Item Name: Crosstube Turning Detail

DART AEROSPACE LTD		Work Order: 101937
Description: Crosstube Assembly (205/212/412 High Fwd)		Part Number: D212-664-141
Inspection Dwg: D212-664-141 Rev: D		Page 1 of 2

DRAWING NO. D212-664-141	TITLE XTUBE ASSY (205/212/412 HI FWD)	REV. D	DART AEROSPACE LTD ENGINEERING ORDER		D.E.O. NO. D212-664-141-D-1	SHEET NO. SHEET 1 OF 2	SCALE NTS
DRAWN	CHECKED	OP	MFG. APPR.	REI	APPROVED	MP	DE APPR.
DATE 11.04.07	DATE 11.07.11		DATE 11.04.12		DATE 11/04/12		DATE 11.04.12

**D212-664-141/-141B
ASSEMBLY DETAIL**

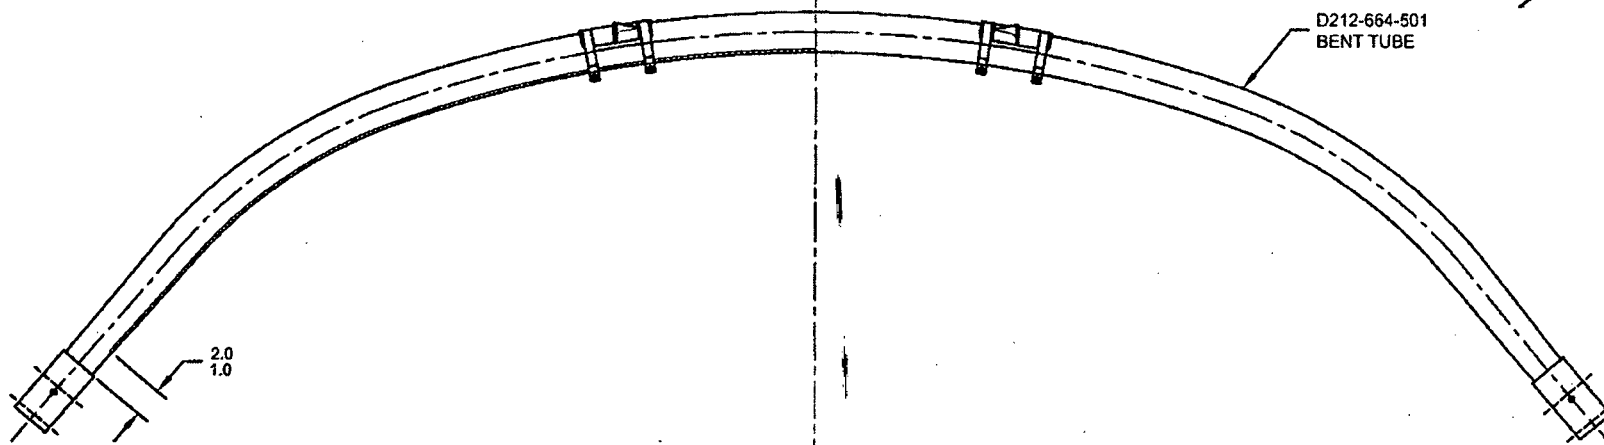
PURPOSE:

ADD AN INSPECTION WINDOW TO UNDERSIDE OF CROSSTUBE.

NOTES 2 OF SHEET 1 IS AMENDED AS FOLLOWS:

IS:

WAS:

- 2) FINISH: CHEMICAL CONVERSION COAT PER DART QSI 005 4.1
PRIME INSIDE AND OUTSIDE PER DART QSI 005 4.2
MASK UNDERSIDE OF CROSSTUBE AS SHOWN (HATCHED AREA) AND
PAINT OUTSIDE PER DART QSI 005 4.2
REMOVE MASKING AND APPLY CLEAR COAT

MASK AREA PRIOR TO PAINTING,
REMOVE MASKING AFTER PAINT
AND APPLY CLEAR COAT
